From: [Piantka, George](#)
To: ["Murphy/Perkins"](#);
cc: [Laurie B. Jester; kchristensen@elsegundo.org; lyle cripe; Doris Nickelson; Nickelson, Nick; McKinsey, John; Riesz, Ken; Seipel, Scott; Dyas, Mary@Energy; Sisk, Tim;](#)
Subject: RE: El Segundo Energy Center (00-AFC-14C) - Transmittal of VIS-9 Figures Per Conditions 5 and 6 of Joint Statement of Agreement
Date: Sunday, January 27, 2013 12:06:39 PM
Attachments: [PL-GRADING-1-20scale-22x34.pdf](#)
[5408-PL-003.pdf](#)
[5408-PL-007_01.21.13.pdf](#)
[VIS-2 Pallet \(2\).pdf](#)
[5408LCP001 Plant Palette.pdf](#)

Cc: lyle cripe <lylecripe@gmail.com>; Doris Nickelson <dorisnickelson1@verizon.net>; Nickelson, Nick <nicknmf@verizon.net>; Laurie B. Jester <ljester@citymb.info>; kchristensen@elsegundo.org <kchristensen@elsegundo.org>; Dyas, Mary@Energy <Mary.Dyas@energy.ca.gov>; John A. McKinsey <jamckinsey@stoel.com>; Seipel, Scott; Riesz, Ken
Subject: Re: El Segundo Energy Center (00-AFC-14C) - Transmittal of VIS-9 Figures Per Conditions 5 and 6 of Joint Statement of Agreement

EL SEGUNDO ENERGY CENTER
 301 VISTA DEL MAR BOULEVARD
45th STREET BERM
REVISED CONCEPT STUDY

PLANTING PLAN FOR:
EL SEGUNDO POWER REDEVELOPMENT PROJECT
 SHEET **4**
 OF 13 SHEETS

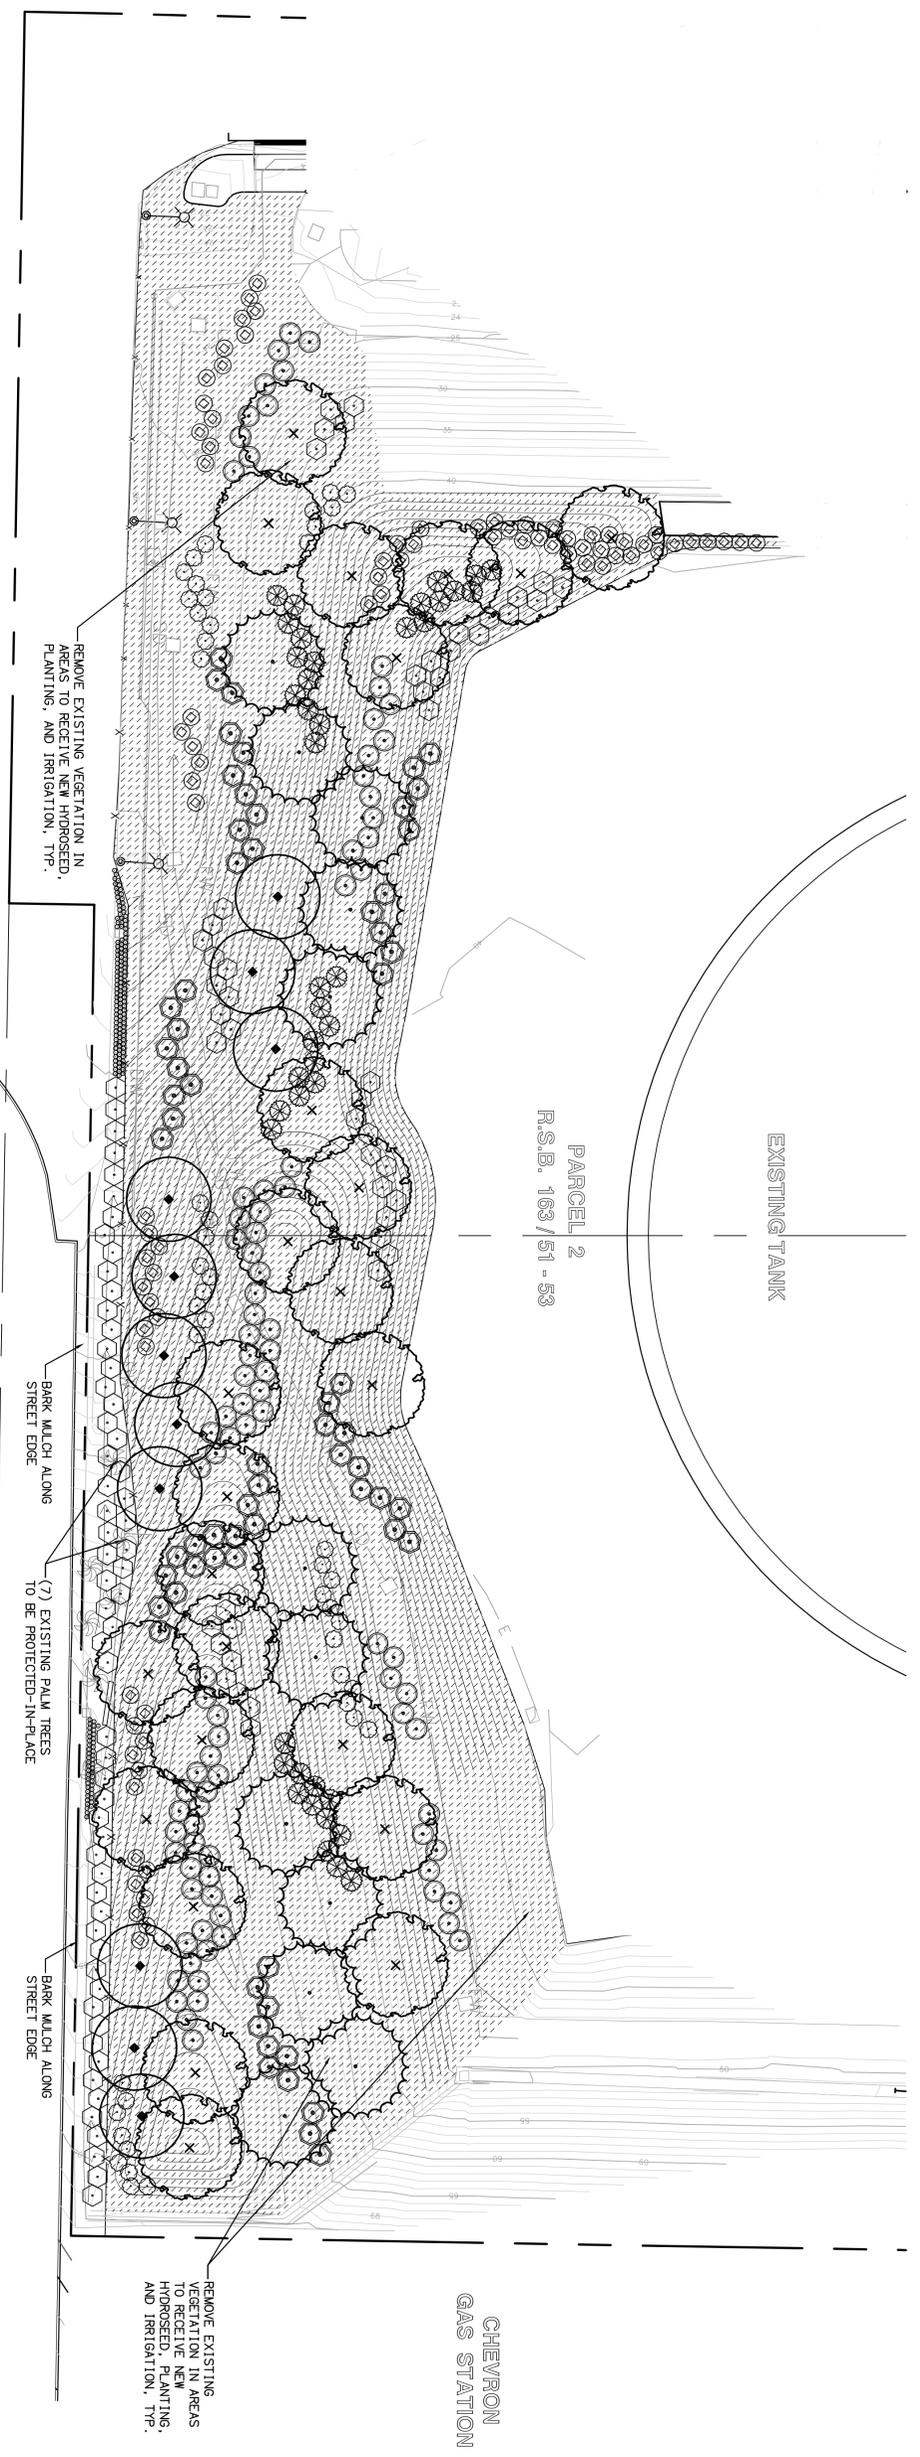
4. We believe the Commission has ordered that the entire berm (as well as the flat areas) is to be planted and maintained with more than "hydroseeding", not just the top part of the berm. Again, if the owners will explain their intentions, this may not be a disagreement at all. Drawings showing how and where the plant palette is to be deployed would be helpful here. In their absence, the notation "remove existing vegetation" on the "Planting Plan" George forwarded raises concerns.

Yes, substantial planting is required beyond hydroseeding and you can see that in the other drawing we provided (i.e., "Sheet 4"). The other drawing is also required to be provided pursuant to the JSA. It is the revised planting diagram and we provided that along with the Sheet 1 to Appendix B of the VIS-2 landscaping plan. The revised planting sheet has a number "4" in the lower right hand corner of the drawing.
